From: Schiller, Alina
Sent: Monday, March 30, 2020 1:11 PM
To: Vogtle PEmails
Subject: Vogtle Units 3 and 4 Technical Exchange - LAR-20-003 [LAR 232]: Technical Specifications ESFAS-VES and Vacuum Relief
Attachments: UFSAR, TS, Bases Markups --DRAFT for Tech Ex Call.pdf; LAR-20-003 [LAR 232] Technical Exchange Meeting [NRC].pdf

- A. **First change:** Identify that Class 1E 24-Hour Battery Charger Undervoltage is a credited actuation of Main Control Room (MCR) Emergency Habitability System (VES) and de-energization of MCR air supply radiation monitor sample pumps. Impacts Updated Final Safety Analysis Report (UFSAR) and Technical Specifications (TS)

Main Control Room Emergency Habitability System (VES) Undervoltage Actuation and Vacuum Relief Valve Technical Specification Changes (LAR-20-003)

Extract from UFSAR Figure 7.2-1 Sheet 15

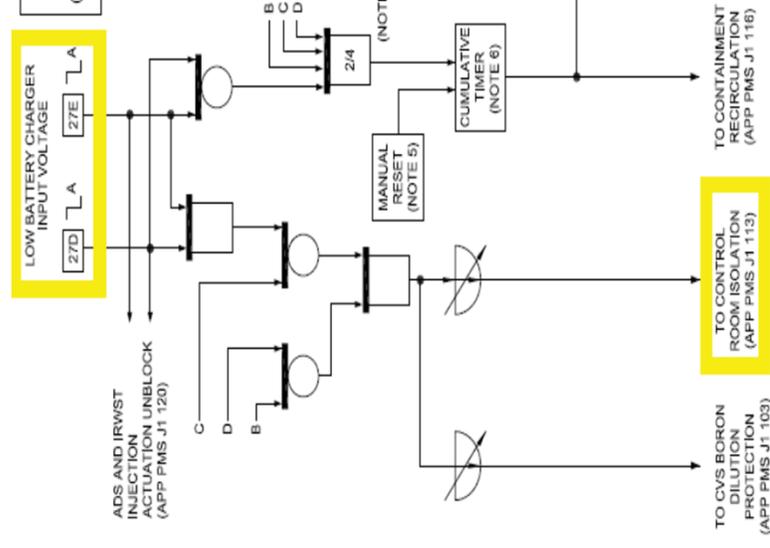
- Shows logic requiring both UV relays in each Division then Divisional signals from A or C AND B or D to produce the Undervoltage actuation shown on UFSAR Figure 7.2-1 Sheet 13

Extract from UFSAR Figure 7.2-1 Sheet 13

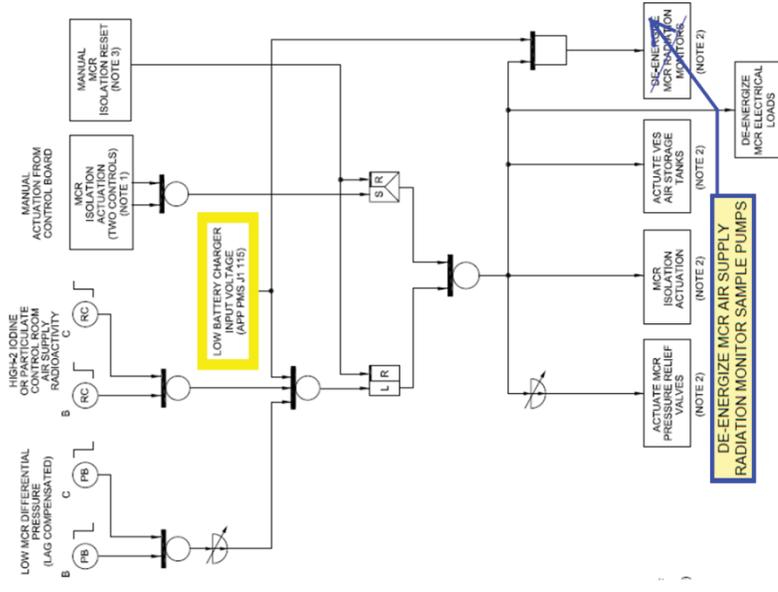
- Shows 3 VES Actuation Signals in the current design
- Shows Battery Charger Input Voltage Low “AND” VES Actuation Signal (any one of 3) leading to De-energize MCR Radiation Monitor (being corrected to clarify that “sample pumps” are being de-energized)
- Battery Charger Input Voltage Low (and sample pump de-energization) is already included in the design, but now being recognized as a Function credited in the Battery Load profile assumptions (meeting 10 CFR 50.36 criteria); therefore being added to Technical Specifications (TS)

- A. The first change would revise the following UFSAR and Technical Specifications (TS):
1. UFSAR Figure 7.2-1 (Sheet 13 of 21) to revise the functional block to state “DE-ENERGIZE MCR AIR SUPPLY RADIATION MONITOR SAMPLE PUMPS.”

Extract from UFSAR Figure 9.4.7-1 Sheet 1

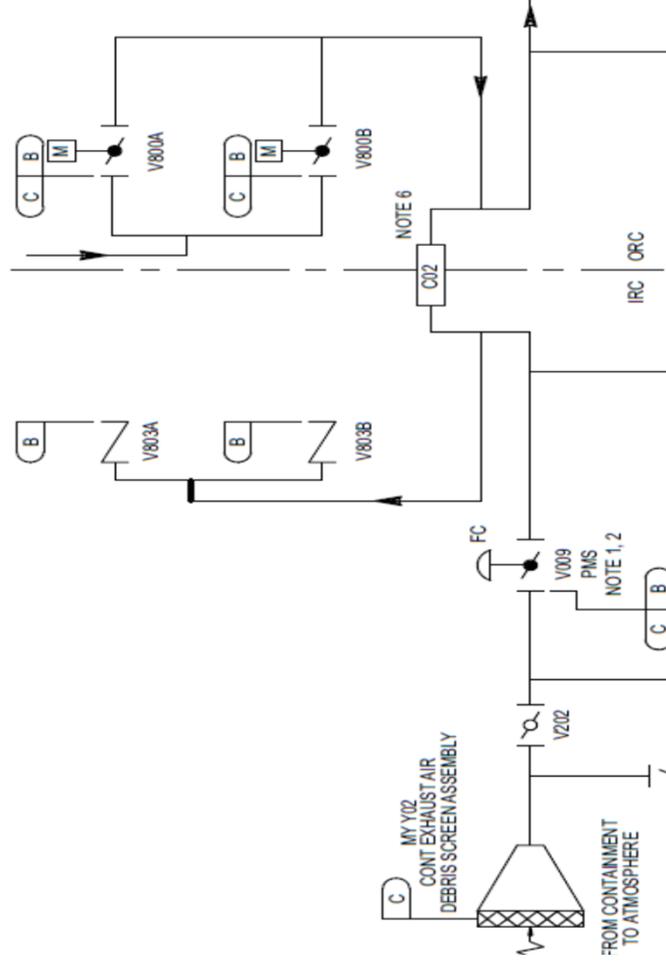
- C. The third change would revise TS 3.6.3, Containment Isolation Valves, to exclude the vacuum relief containment isolation valves, and revise TS 3.6.9, Vacuum Relief Valves, to address operability of the containment isolation function, Actions, and Surveillances.

Extract from UFSAR Figure 7.2-1 Sheet 19

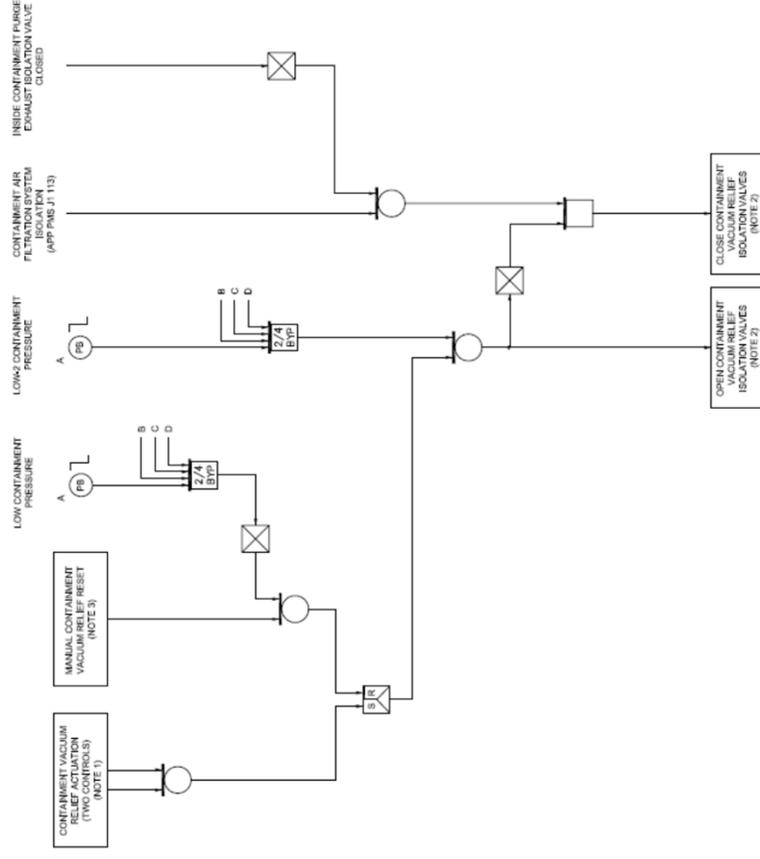
However, the Actions for a vacuum relief valve that is inoperable for closing are revised to remove the requirement for deactivating or securing the valve closed.
